BNFL-5232-RPT-ESH-07, Rev. 0

Construction Certification Report for Waste Management Facility –634 for the Advanced Mixed Waste Treatment Project

Subject: **Transmittal of the Construction Certification Report for the AMWTP Waste Characterization Facility (WMF-634) – AM-BN-L-5176**

WMF-634 FACILITY ARRANGEMENT AND GRADING PLAN

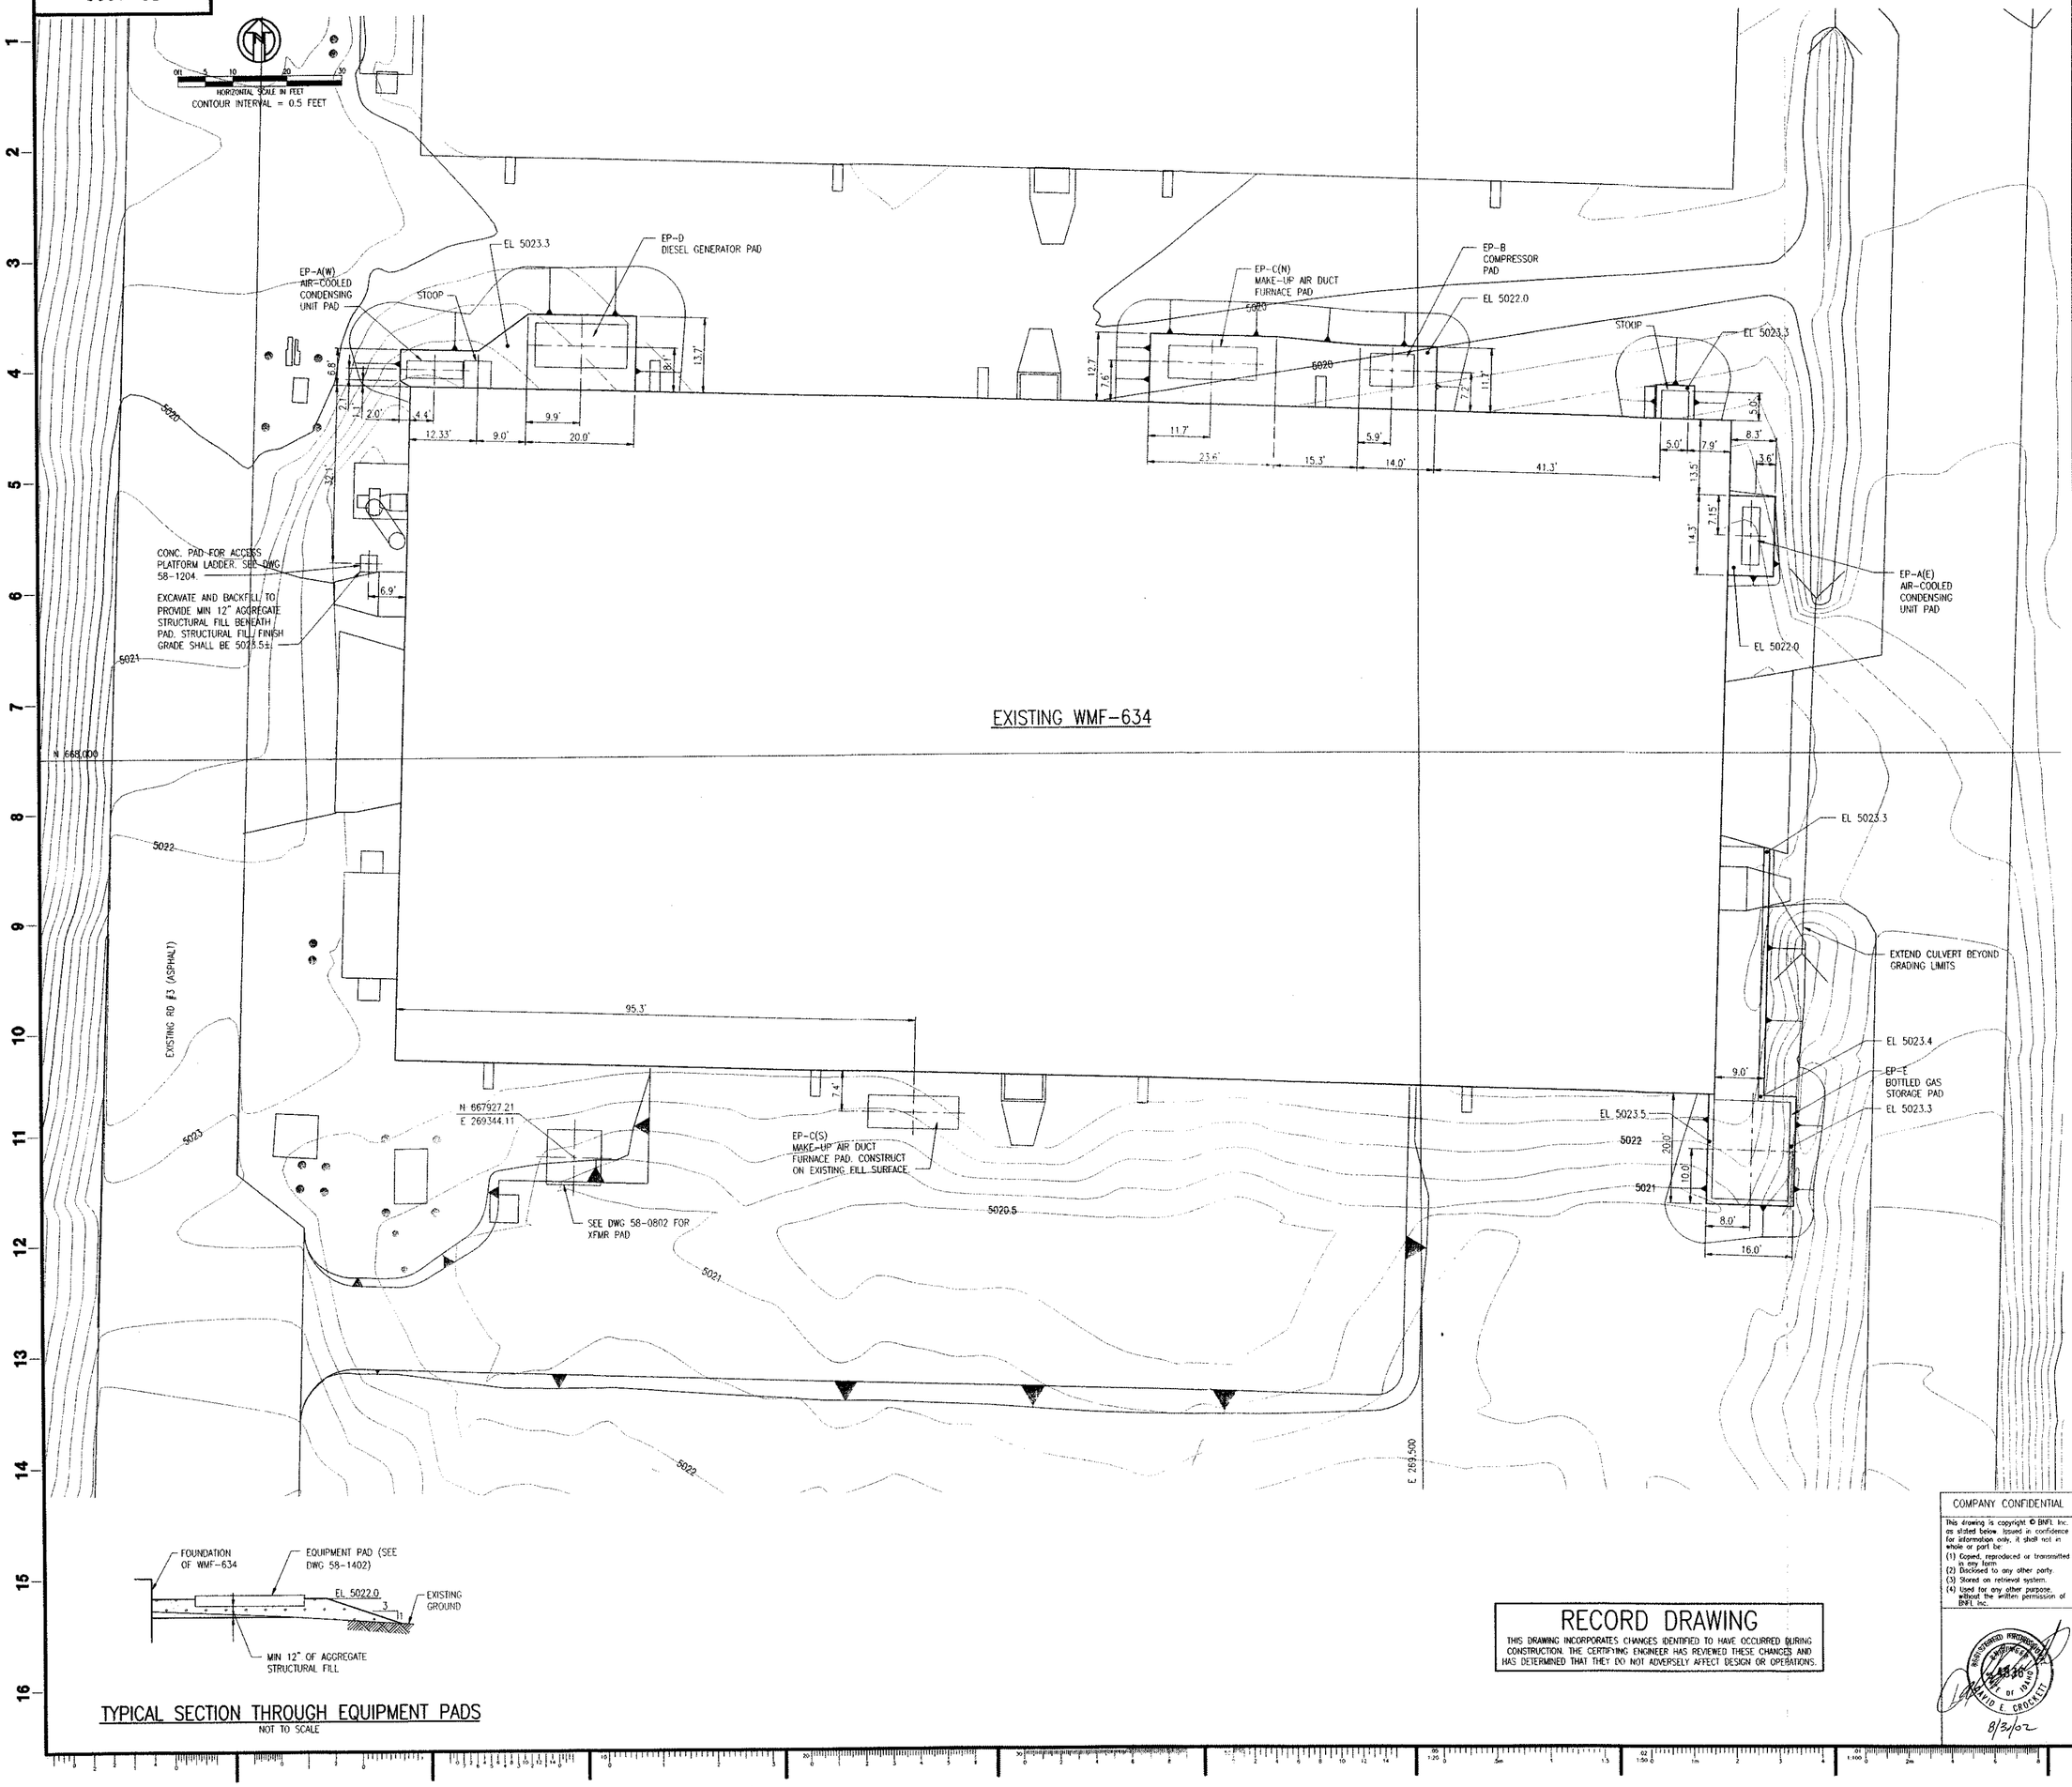
Drawing Number	Revision Number	Minor Deviations To As-Built Drawing[1]	Rational
WMF-634 Facility Arrangement and Grading Plan (continued)			
52-1900	5	Increased the size of the bottled gas storage pad. The storage pad dimensions have been changed from 18 ft to 20 ft (north – south dimension) and from 14 ft to 16 ft (east – west dimension). The storage pad is located at grid point Q11.	Increased the size of the bottled gas storage pad in order to accommodate the relocation of the storage pad, and facilitate proper installation.
		Added a concrete pad for the placement of a transformer. The concrete pad is located on the south side of WMF-634, near grid point E11.	The pad was constructed to accommodate the transformer.
		Revised the size, location, and grading for the EP-D diesel generator pad. The size of the earth pad area has been changed to accommodate the concrete foundation required for the generator. The pad has changed from approximately 11.7 ft (north – south dimension) by 20 ft (east – west dimension) to an approximate size of 13.7 ft by 20 ft. The EP-D generator pad was moved to the north, and the grading elevation references were updated from an elevation of 5022.0 to 5023.3 ft. The generator pad is located at grid point E4.	The pad was expanded to accommodate an increase in the size of the generator.

Increased the size of the earth pad located on the north-east exterior corner of WMF-634. Increased the grading elevation of the concrete pad from 5023.0 ft to 5023.3 ft. The earth pad is located at grid point P4.	The earth pad was increased in size to allow for a level step off surface from the concrete step.
		Added "Record Drawing" Stamp to drawing.	Information provided for completeness.
		The revision boxes have been updated. This included updating the revision number, revision date, revision description, and approvals.	Information provided for completeness.
